MIL-S-19500/219A(EL)
AMENDMENT-6

15 August 1974
SUPERSEDING
AMENDMENT-5
8 February 1972

TRANSISTOR, PNP, GERMANIUM, POWER, SWITCHING
TYPES 2N1651, 2N1652, 2N1653

This amendment forms a part of Military Specification MIL-S-19500/219A(EL) dated 2 April 1963.

FIGURE 3
PULSE RESPONSE TEST CIRCUIT
JAN 2N1651, 52, 53

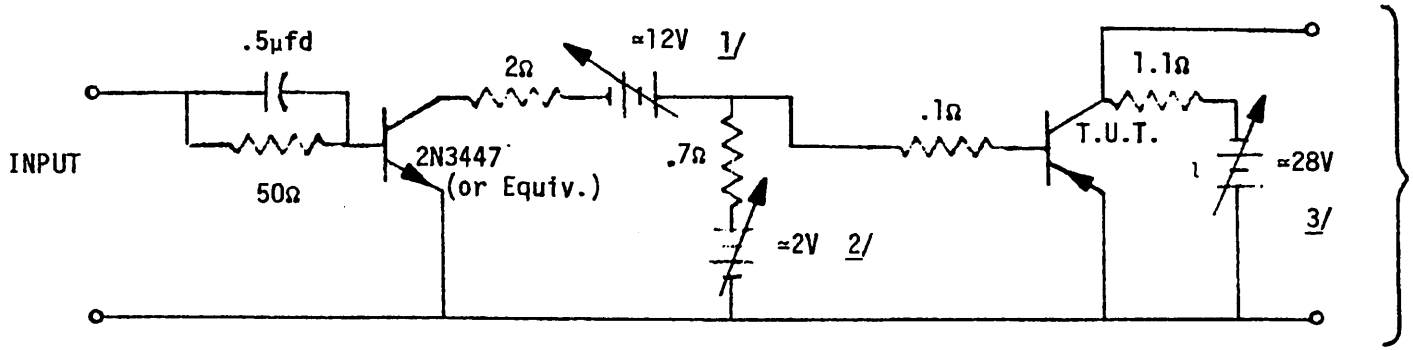
Table 1: Effect the following corrections (of printer's errors) where applicable in particular printed copy of specification on-hand: In Subgroup 3, item 3076, Conditions column, -change "I_C = -25 Vdc" to read "I_C = -25 Adc"; also, in Subgroup 4, item 3251, Conditions column, -change "I_C = -25 Vdc" to read "I_C = -25 Adc". Add reference; see figure 3.

Add new figure 3 which becomes new page 10.

NOTES:
1. Adjust for IB1 = 2.5A
2. Adjust for IB2 = 2.5A
3. Adjust for IC = 25A

INPUT PULSE: Width 50µsec
Duty Cycle 10%

SCOPE: $t_r \leq 20$ nsec
$Z_{in} \geq 1$ megohm
$C_{in} \leq 20$pf
